DCC25-0007

Wells Fargo Addition & Modifications

March 3, 2026 City Council Meeting

Staff Analysis – DSD Architectural Requirements

EAST ELEVATION - PROPOSED - UP TO L5

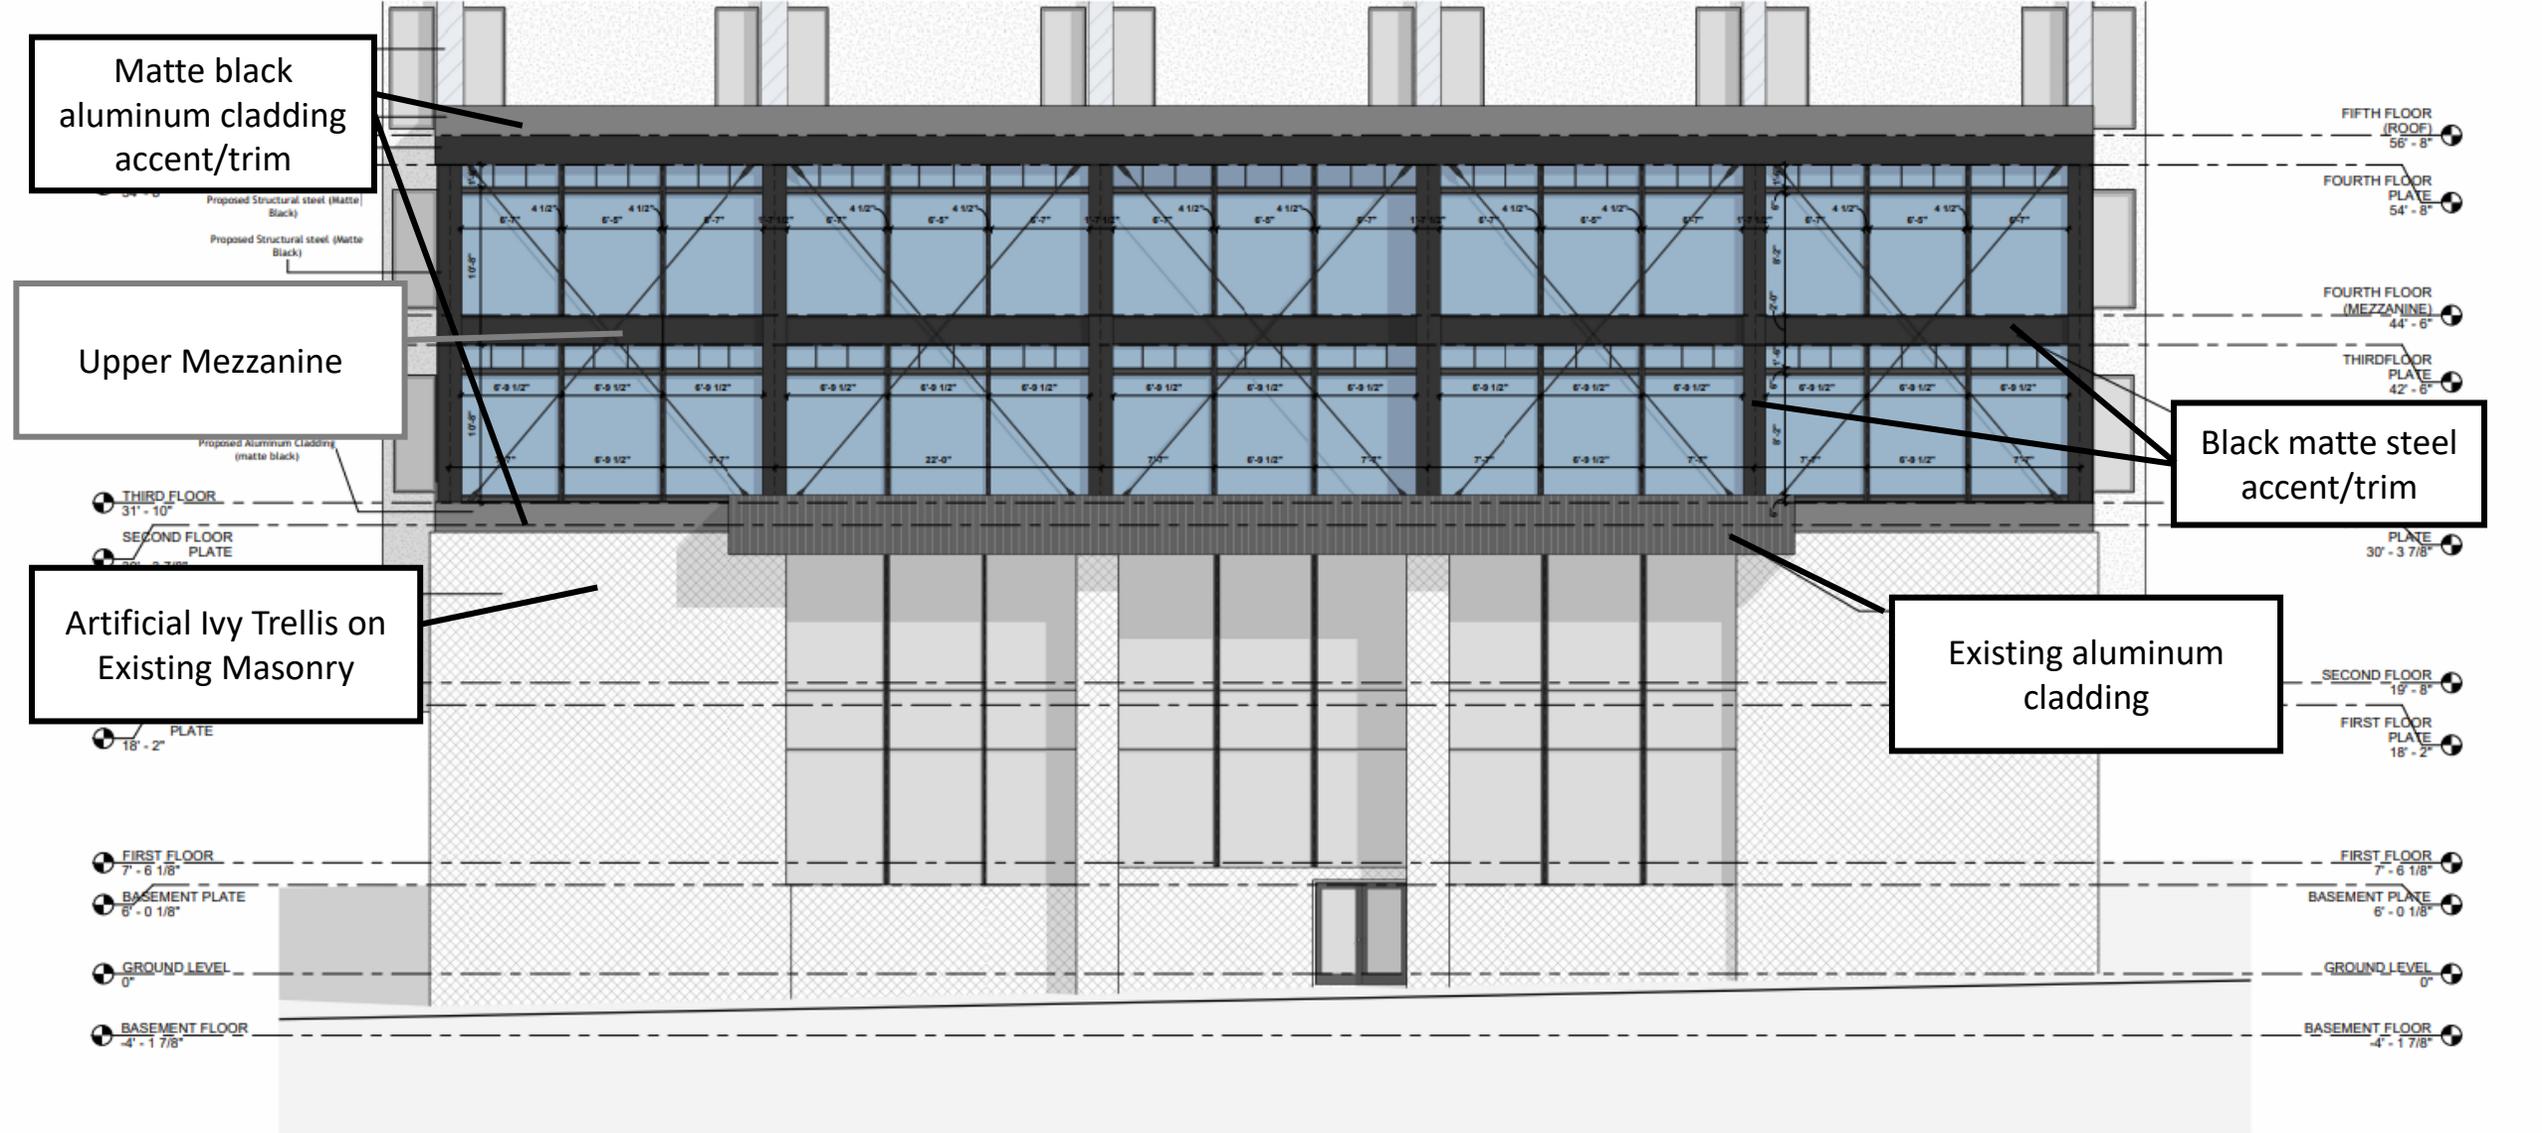
- Proposed east addition creates clear visual differentiation between the existing and new floors.
- Addition of ivy trellis, and retention of the awning, create the appearance of a single story with an addition above
- Proposed black matte steel and aluminum are permitted accent and trim materials.

SOUTH ELEVATION - PROPOSED

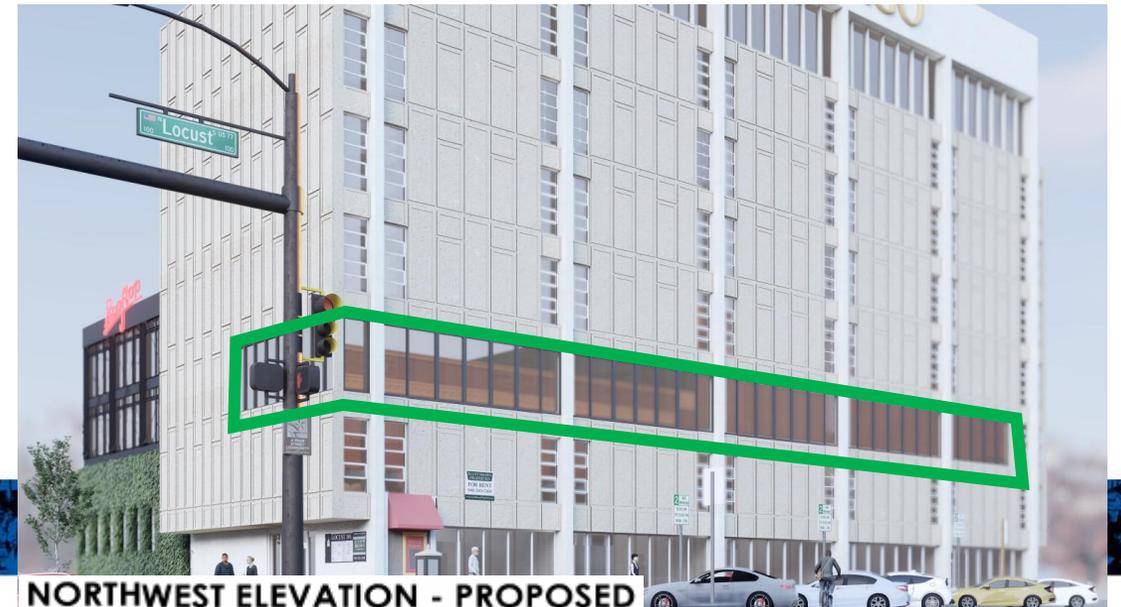
- Overall height does not exceed maximum height of 65' fronting on a Mews Street (S Austin Street)
- Overall visual appearance of a three-story façade, consistent with standards:
 - Existing structure with ivy and awning appears as a single “base” story.
 - Addition of one story and upper mezzanine appears as upper two stories.
